Chestfield Parish Council

19 April 2017

CA/17/00469/OUT - Grasmere Gardens, Land South of The Ridgeway, Chestfield

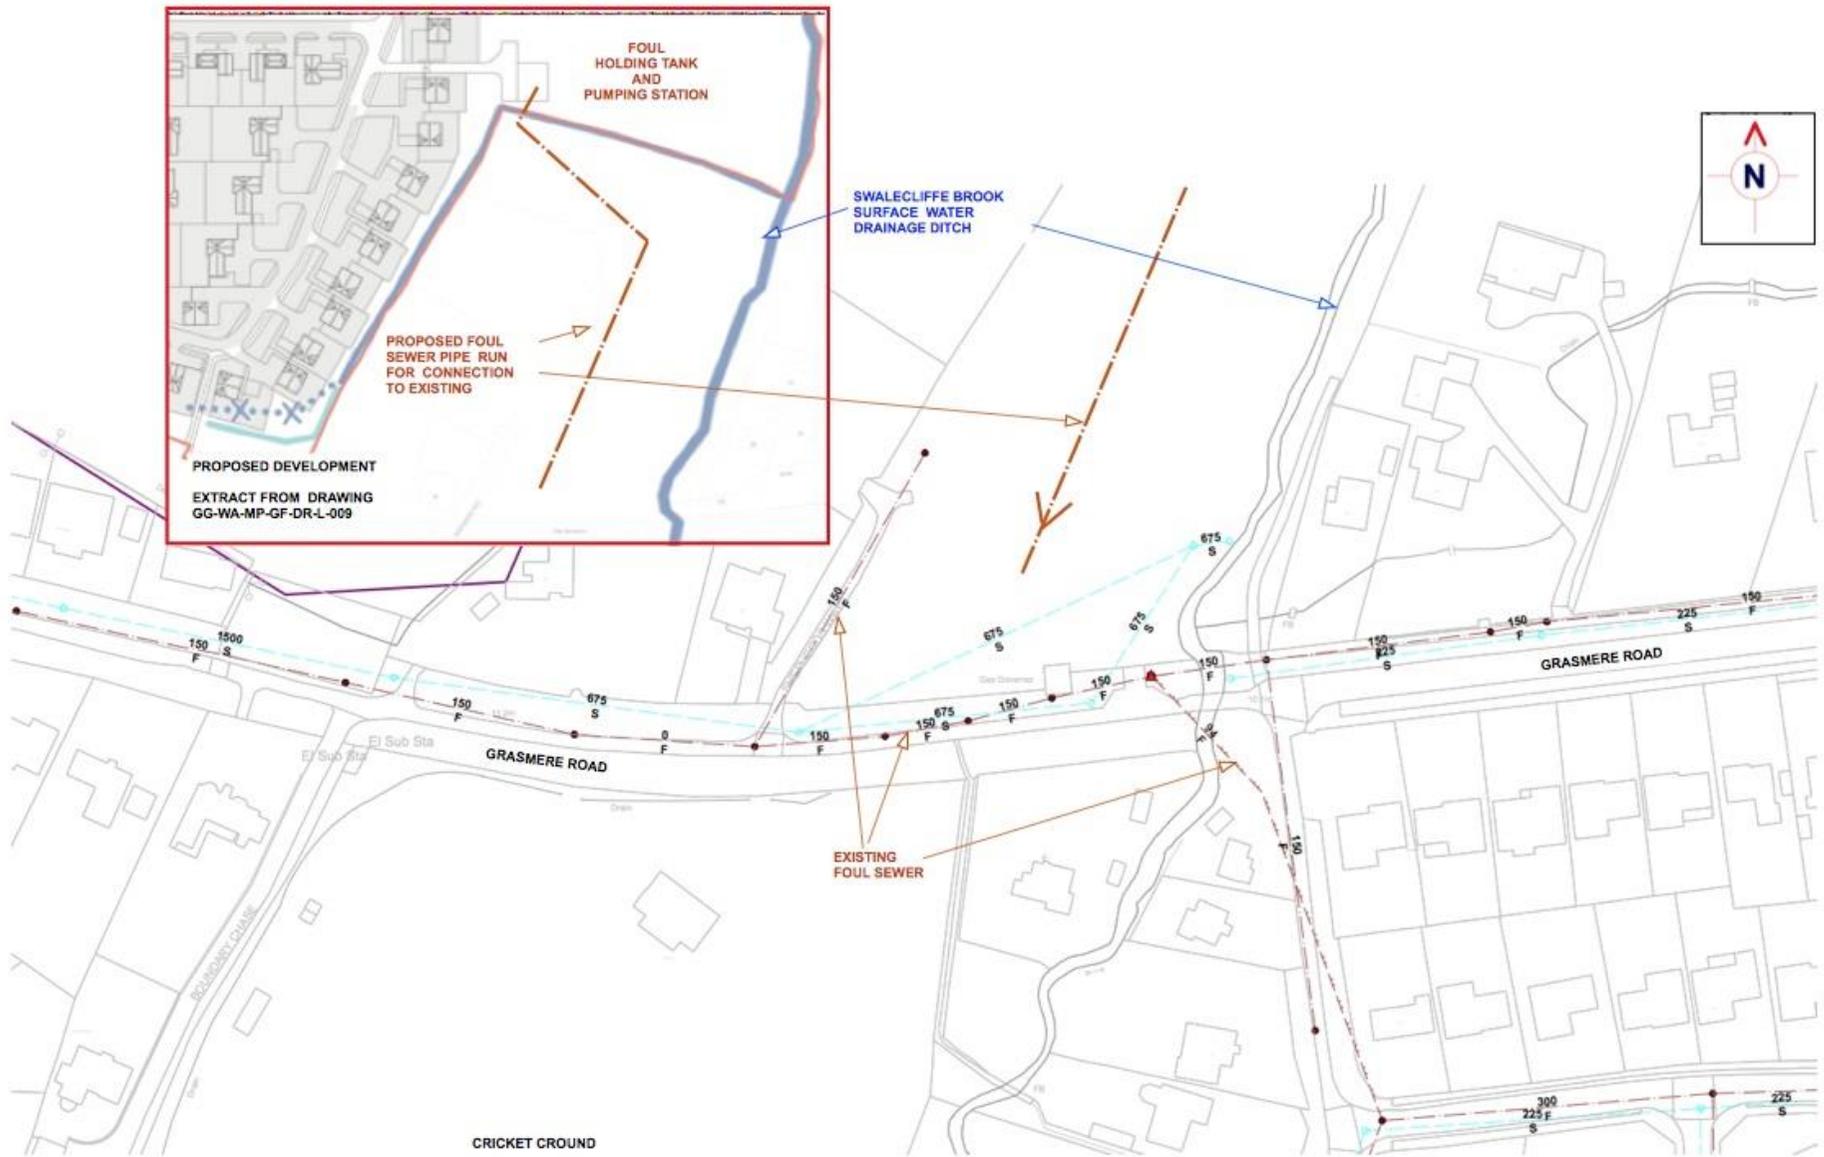
We are confident that there is a real problem of capacity regarding foul drainage. We have photographic evidence of the drain at the end of Chestfield Road (opposite the entrance to Maydowns Road) at the Chestfield/ Thanet way roundabout by the train station badly overflowing and flooding the road across its width after very heavy rainfall.

Application CA/17/00469
 GRASMER PARK
 WHITSTABLE KENT
 Drg Title FOUL DRAINAGE
 GRASMER RD

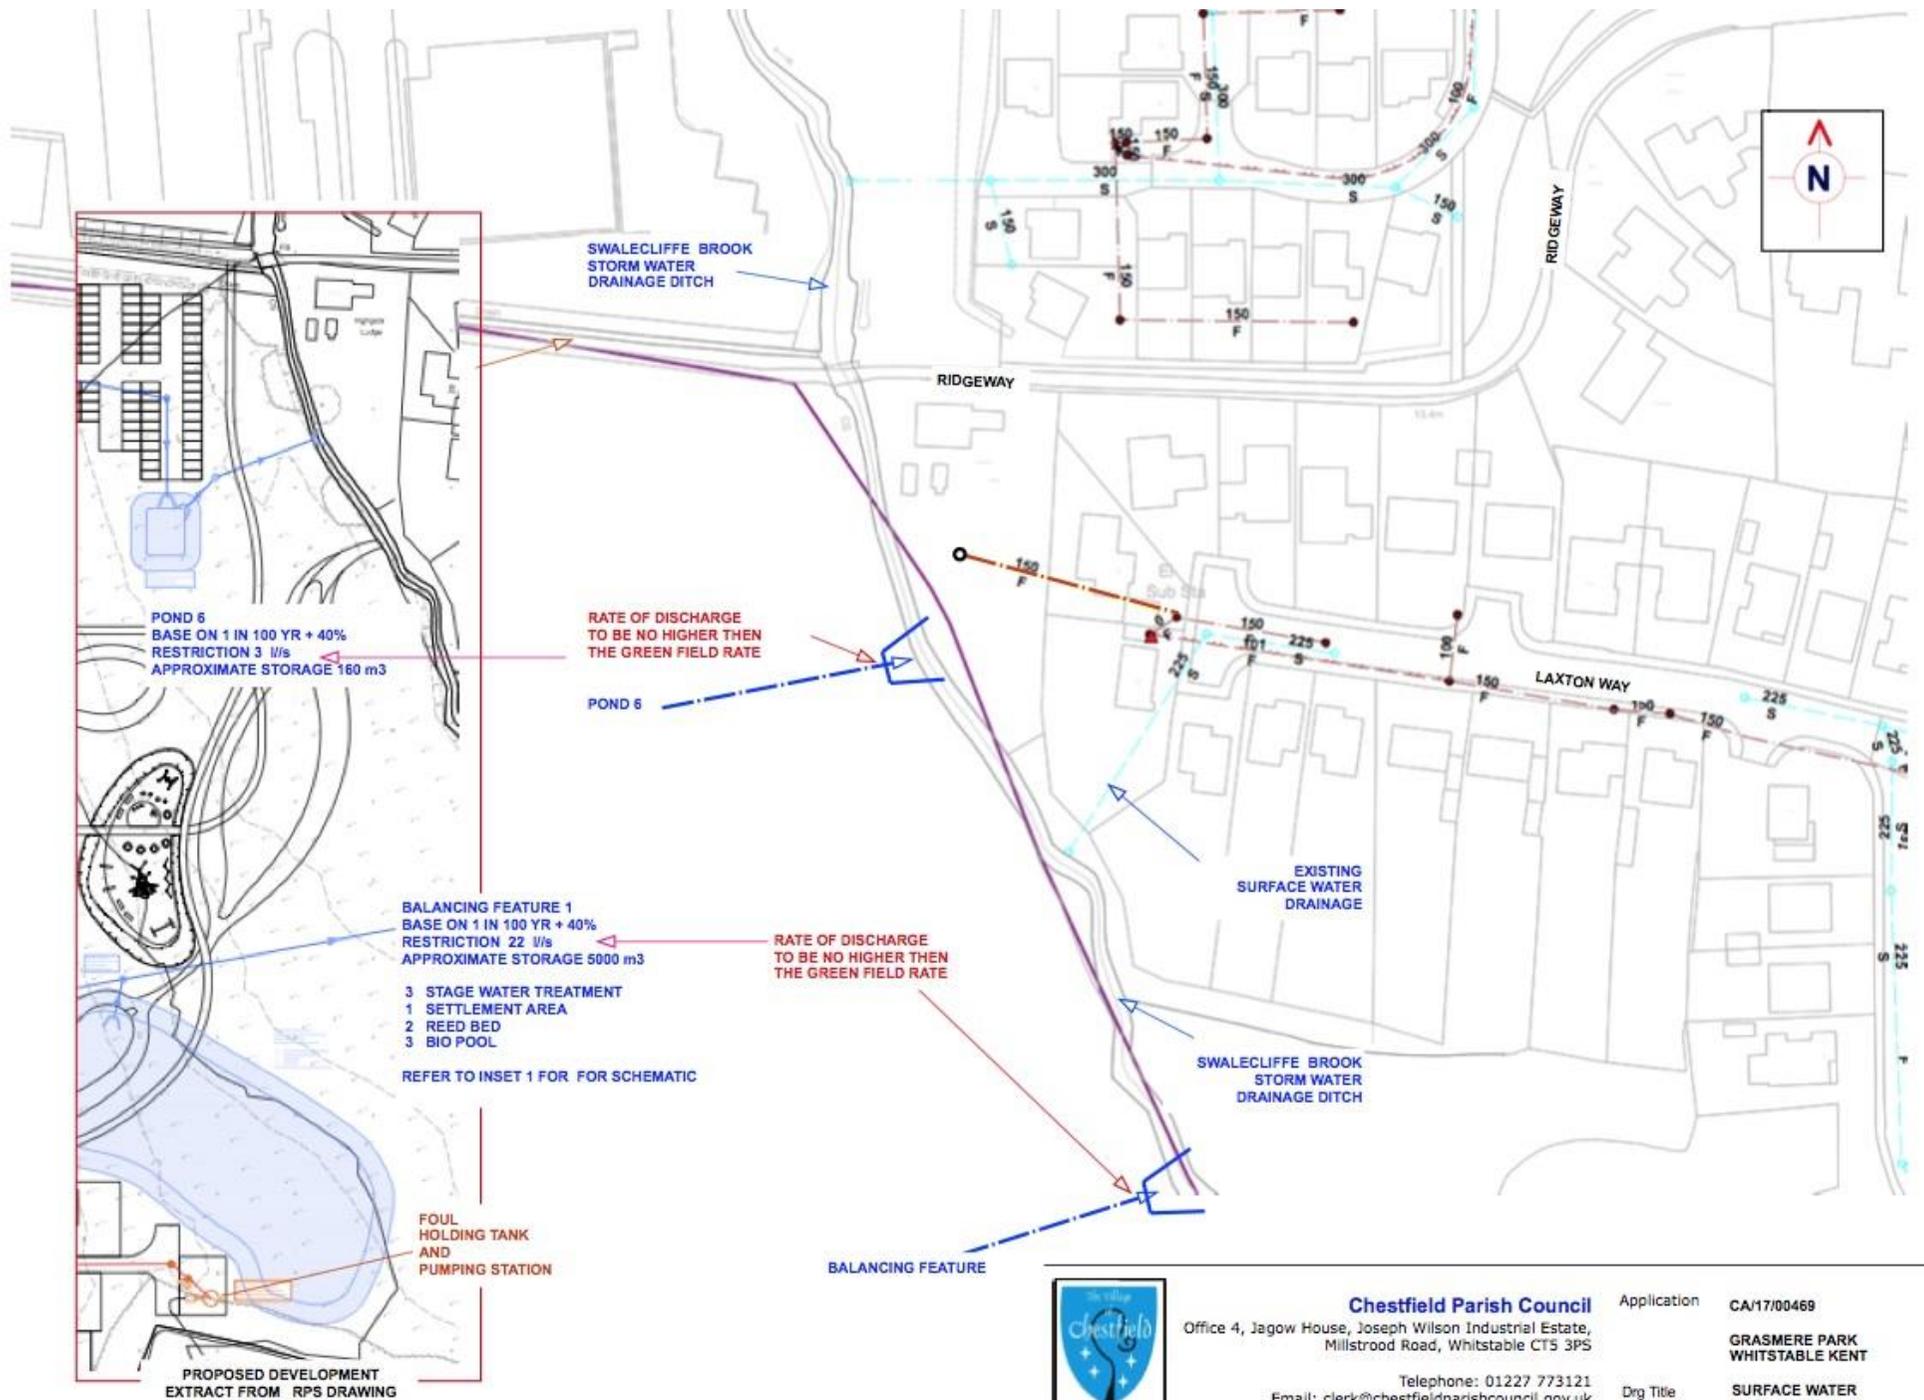
For Foul Drainage we feel that the application is deficient in that it does not detail an appropriate point of connection to a foul sewer network to discharge foul drainage from the development. The submitted plans indicate that the foul sewer from the proposed pumping station will be connected to an existing 150mm diameter sewer at the head of the a run in Grasmere Road (see reference drawing below): we question whether the 150mm diameter pipe have the capacity to take the overnight flow.

- a) The pumping station connects to an existing 150mm diameter sewer in Grasmere Road: does this have the capacity?
- b) Who is responsible for the maintenance of the Holding Tank?
- c) Assuming over-night pumping, is the existing sewer at the end of Chestfield Road adequate for the increased night flow?
- d) A capacity check needs to be obtained from Southern Water to confirm that the existing sewers are adequate to serve this development.
- e) Approval in principle needs to be obtained from Southern Water prior to granting planning permission.
